IEEE P802.15
Wireless Personal Area Networks

Project	IEEE P802.15 Working Group for Wireless Personal Area Networks (WPANs)	
Title	Power Management Message Sequence Charts	
Date Submitted	13 November, 2001	
Source	Jay Bain Time Domain7057 Old Madison Pike Huntsville, AL 35801	Voice: 256 922-9229 Fax: 256 922-0837 E-mail: jay.bain@timedomain.com
	Mark E. Schrader Eastman Kodak Co. 4545 East River Road Rochester, NY 14650-0898	Voice: 716-781-9561 FAX: 716-781-9533 E-Mail: mark.e.schrader@kodak.com
Re:	IEEE Draft P802.15.3/D0.8	
Abstract	This document provides recommended message sequence charts for the power save clauses of the 802.15.3 MAC to be incorporated into D0.9	
Purpose	The recommendations contained in this document are to be applied to the 802.15.3 MAC baseline, in conjunction with document 01/485r4 CTA Changes for Power Management and Resynchronization	
Notice	This document has been prepared to assist the IEEE P802.15. It is offered as a basis for discussion and is not binding on the contributing individual(s) or organization(s). The material in this document is subject to change in form and content after further study. The contributor(s) reserve(s) the right to add, amend

Figure 64 - Operation of EPS mode channel time requests

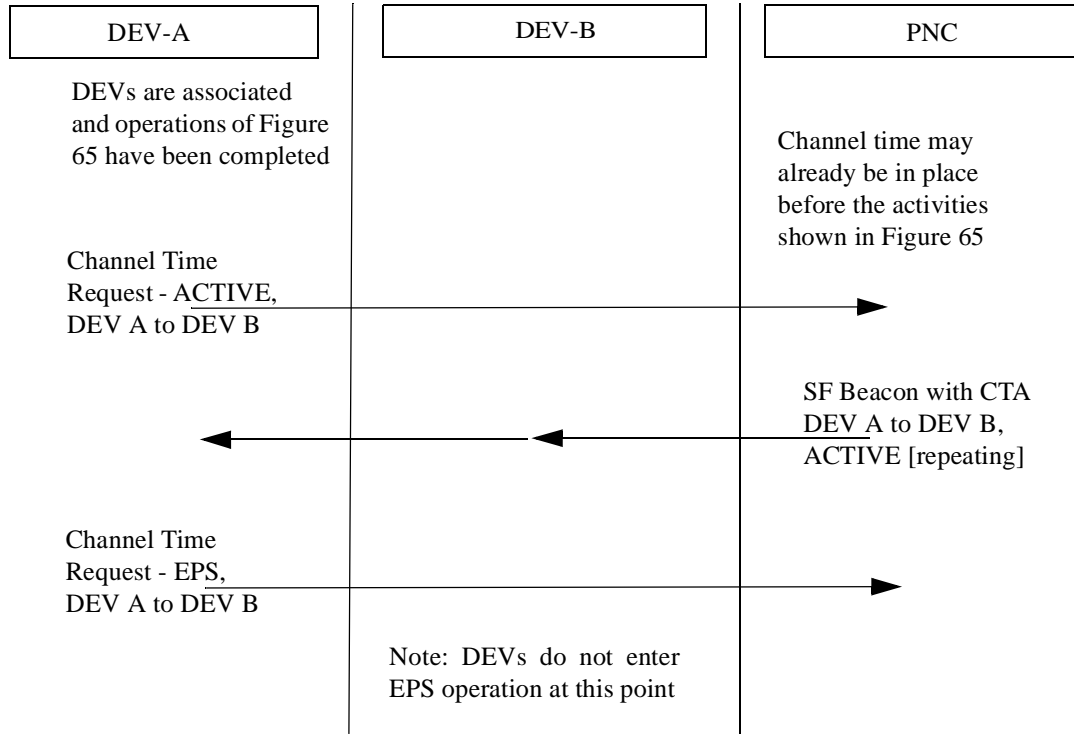
multiple graphics for clause 8.12.3.1 in place of the single reference of d0.7

This is the first graphic and covers the channel time request process for DEVs that will operate in EPS mode.

Figure xx - Operation of EPS mode switching

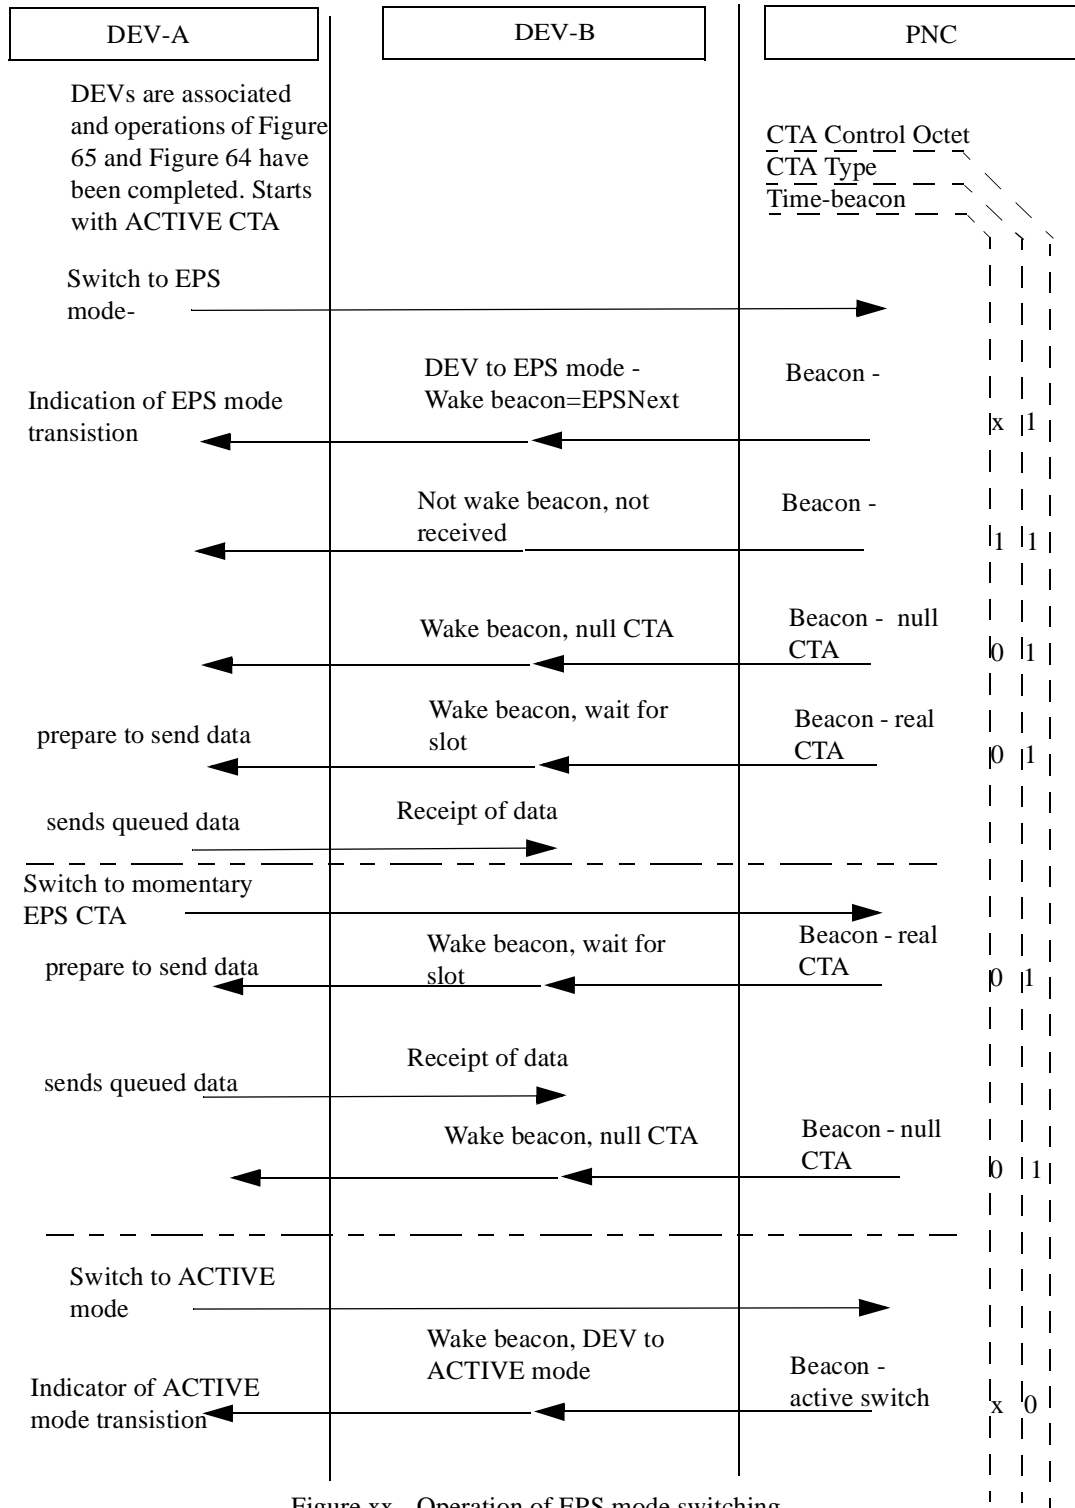
This next graphic is the message sequence chart for the control sequences for EPS, ACTIVE, and the use of momentary

Figure 65 - Illustration of the EPS control process

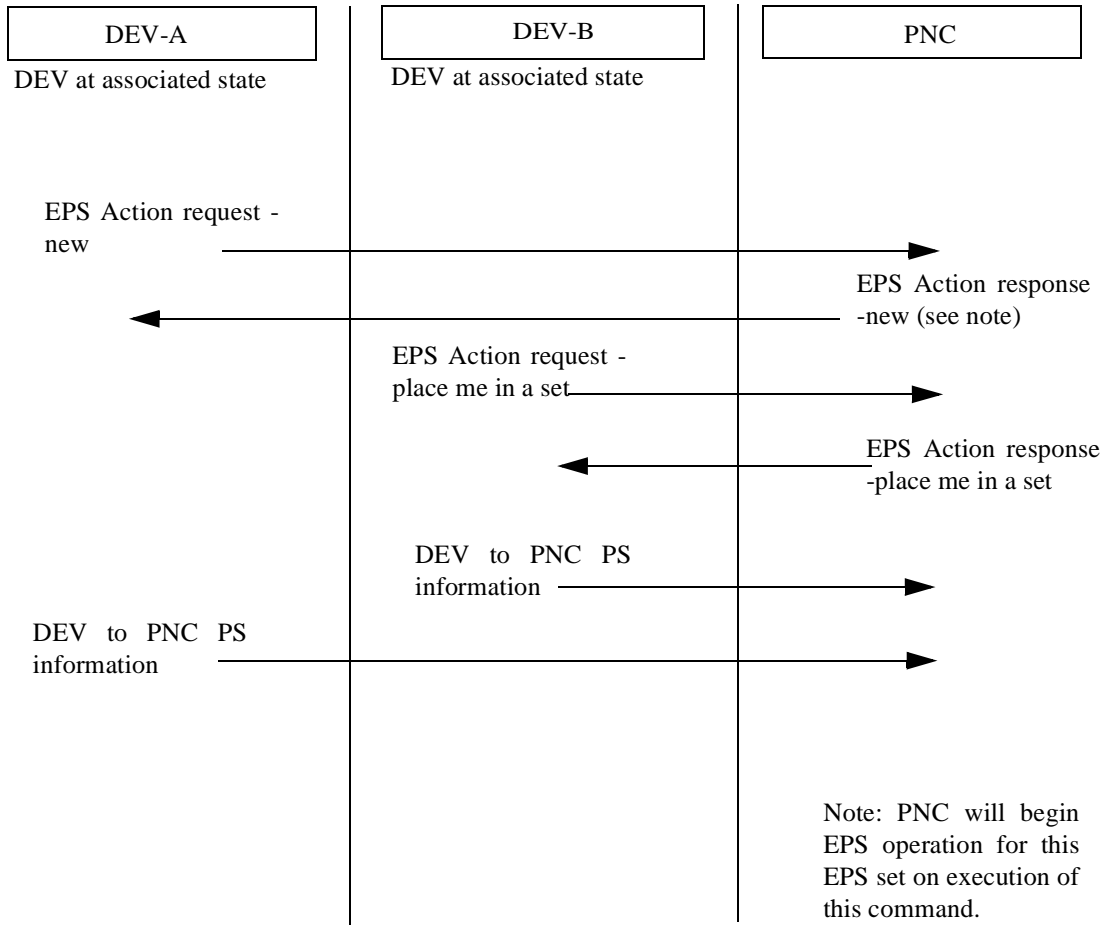
the following is the message sequence chart for initial setup of EPS DEVs and is placed in clause 8.12.3.3
